Agenda Item: 7.5, 12.1, 13.4
Source: Telia
Title: Iu transport for the packet domain
Document for: S3.10, S.3.14, S3.12

Figure 1: Iu protocol stack for the packet domain

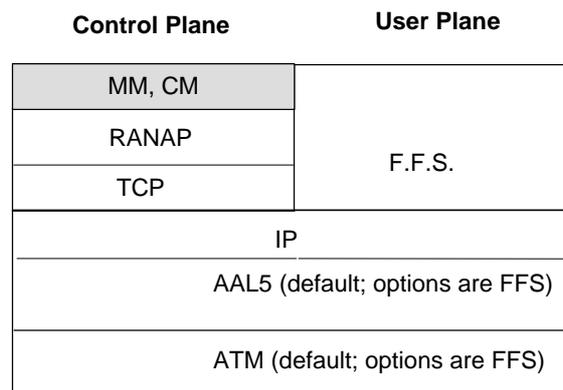
In the previous RAN-WG3 meeting it was agreed to include IP in the protocol stack for the user plane of the packet domain. The right hand part of Fig 1 below was taken as an initial working assumption. The left hand part of Fig 1 (control plane) was not agreed.

It is clear that the statement within parenthesis of the L1-L2 transport layers in Fig 1 require some clarification. This needs to be reflected in the documentation.

1. The following text should be added in S3.10, ch. 4.2 and/or in S3.14, ch. 6.1:
 - ATM and AAL5 shall be supported as the default L1 and L2 transport layers. Other transport layers are allowed as options in the standard.
2. The following text should be added in S3.10, ch. 4.2 and/or in S3.12, ch. 5.1:
 - Signalling in the control plane shall not depend on the specific choice of transport layers, e.g. ATM and AAL5.
